Technical Bulletin

97 14 01 April 8, 2014 2036976

Under Hood Fuse Panel (SA/SB assembly) with part number 000 937 125 Supplied Without Power Distribution Bar (SA panel)

Figure 1

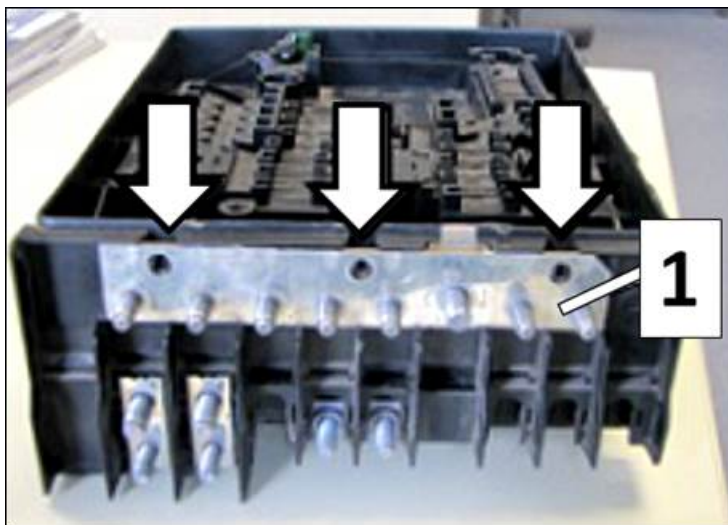
The supplied under hood fuse panel (SA/SB assembly) with part number 000 937 125 comes without the power distribution bar (SA panel). When replacing an under hood fuse panel, the technician must remove the power distribution bar from the original under hood fuse panel and install it on the new assembly. See (Figure 1) below.

Carefully remove the power distribution bar (Figure 1, number 1) with a suitable tool such as a small pocket screwdriver in the area of the three arrows (Figure 1).

Install the power distribution bar to the new SB panel.

When using the new SB panel part number 000 937 125, the power distribution bar of the existing SB panel must be removed and installed on to the new SB panel. Make sure that the power distribution bar does not twist or bend.

Figure 2

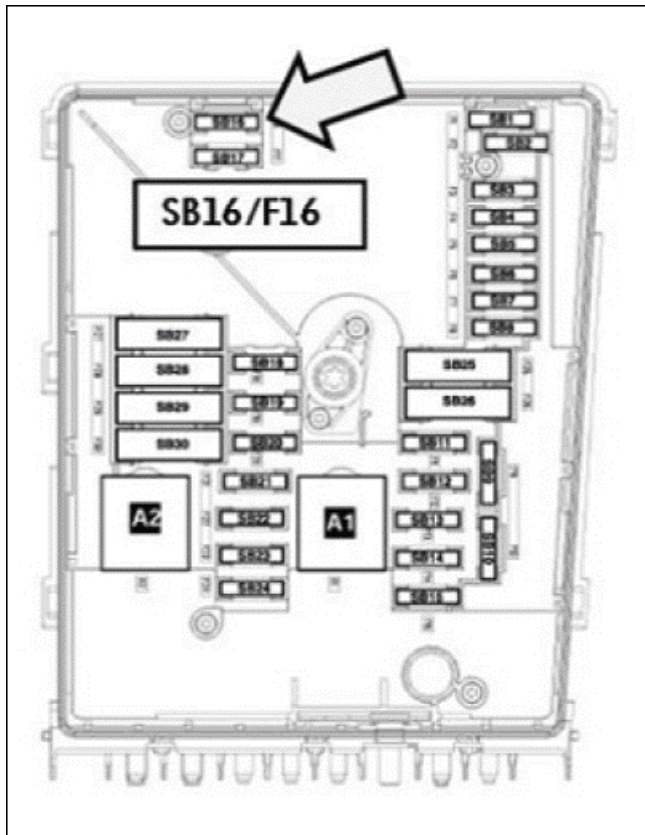
For the position SB 16 (figure 2) a 30 A fuse, part number N 017 131 25 must be used.
